Hendy Windfarm Development Hydrological Impacts

This letter provides a review of both the Environmental Statement (ES) submitted as part of the application to construct seven wind turbines at the Hendy Windfarm by Cunnane Town Planning dated 27th June 2014; and a review of the Surface Water Management Plan (SWMP) prepared by WYG Environment and Planning (Northern Ireland) Ltd dated 15th November 2018. The ES was submitted as part of the initial application and the SWMP was submitted in response to the conditions requested by the Local Planning Authority.

Figure 1. The wind turbine locations shown in red, background map OS 1:25,000 sheet 200.

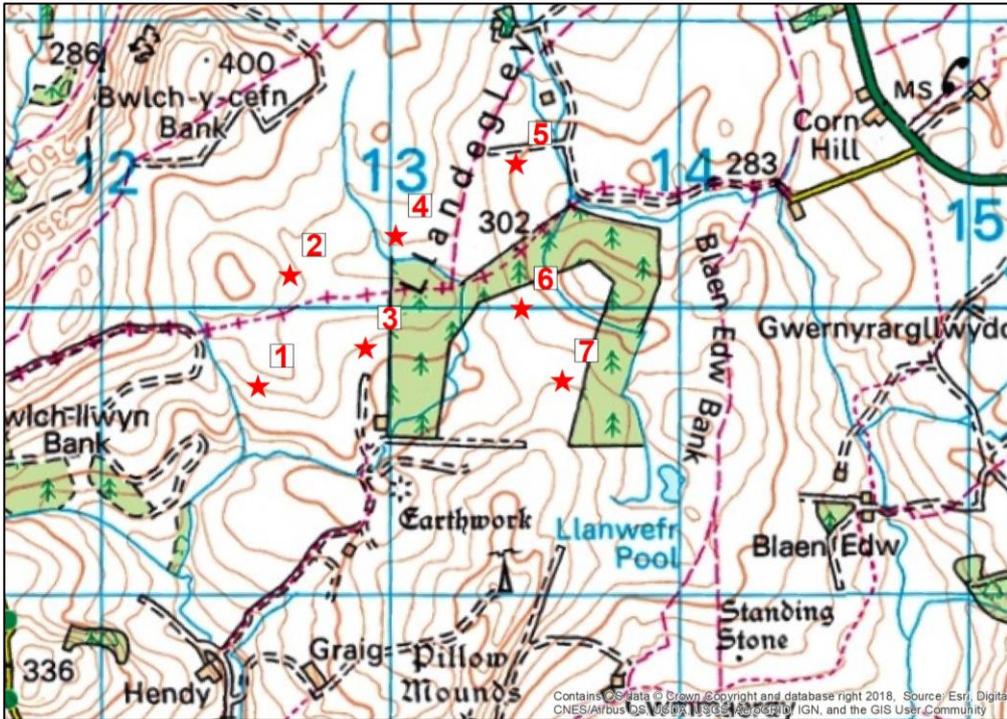
The location of the seven turbine sites are shown in Figure 1. A visit to the site on 11th January 2019 confirmed that the development is an upland area of steep to rolling topography with rough grazing, moorland and forestry, as shown in Figure 2. The area includes the upper reaches of the River Edw (Figure 3) and the Nant Brook - both tributaries of the River Wye which has been designated as a Special Area of Conservation. The visit also confirmed that work had begun on Turbine number 5, the most northerly of the sites which was viewed from the byway open to all traffic in Figure 4. This shows the extent of excavations at the site and the amount of bare soil which has been uncovered.

A proper consideration of mitigation features also needs to be included. It appears that much of the text describing mitigation in the SWMP is simply generic, and in many cases does not consider if these are appropriate for the type of the development and the setting within the landscape. For example, the use of swales is proposed for turbine bases, tracks, compound, sub-station and crane pad construction mitigation. Swales are described in detail in the current SUDS guidelines and are shallow ditches with a 1 in 4 side-slope which are included in designs not to convey water but to collect water from impermeable surfaces and allow the gradual infiltration into the soil/groundwater or loss through evapotranspiration. The swales are described as having a maximum depth of water as 0.3m. To comply with the 1 in 4 side slope each side of the swale would need to cover a distance of 1.2m. Assuming a base of 1m, the total width would need to be 3.4m. The excavation of a swale along side the type of access tracks in the steep to rolling topography of the wind turbine site, such as that shown in Figure 1, would not be possible.

Figure 5. The 20m (yellow) and 50m (pink) buffer around waterways (blue) in the area of the wind turbine development site (red outline). Background map OS 1:10,000 open raster.

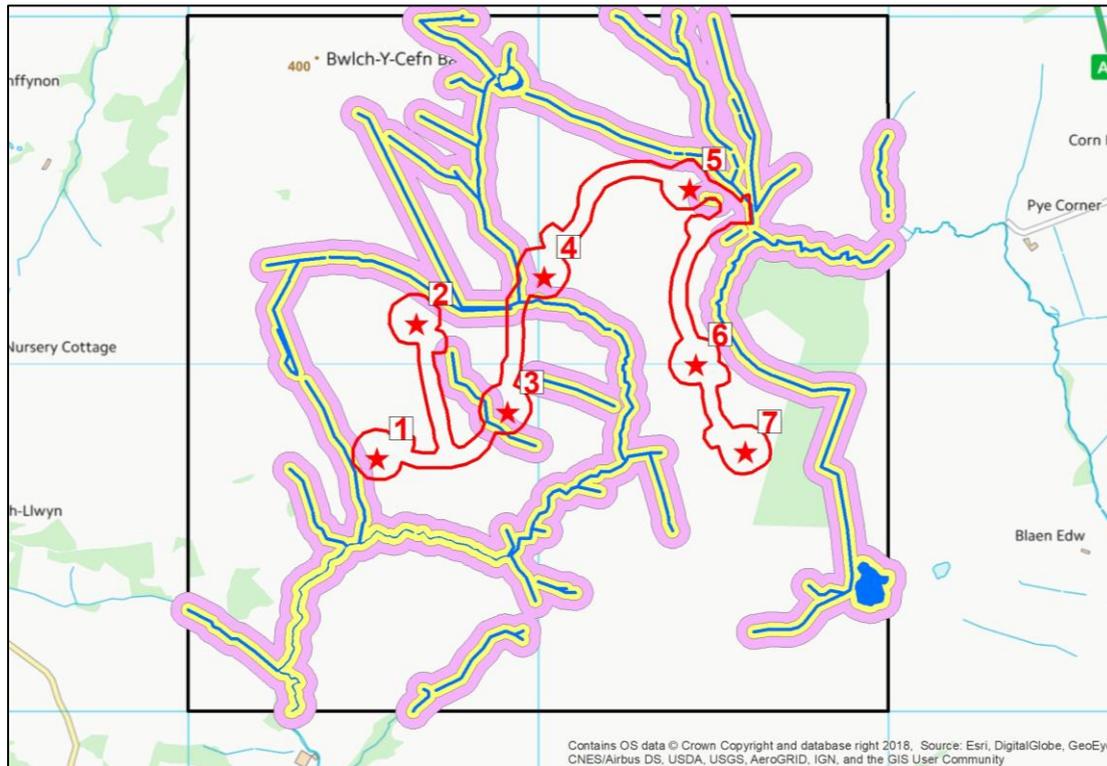
Other methods such as the use of GIS to produce maps and perform spatial analysis should have been demonstrated. For example, a common mitigation method mentioned throughout the SWMP (and ES) is the limiting of any construction work where possible to areas outside buffer from each waterway. The ES used a 20m buffer but the SWMP suggested a 50m buffer. Neither report provided any maps indicating the extent of these buffers in relation to the development area. Such mapping is a relatively straightforward exercise using GIS software. An example of these buffers for the 4km area surrounding the development site is shown in Figure 5.
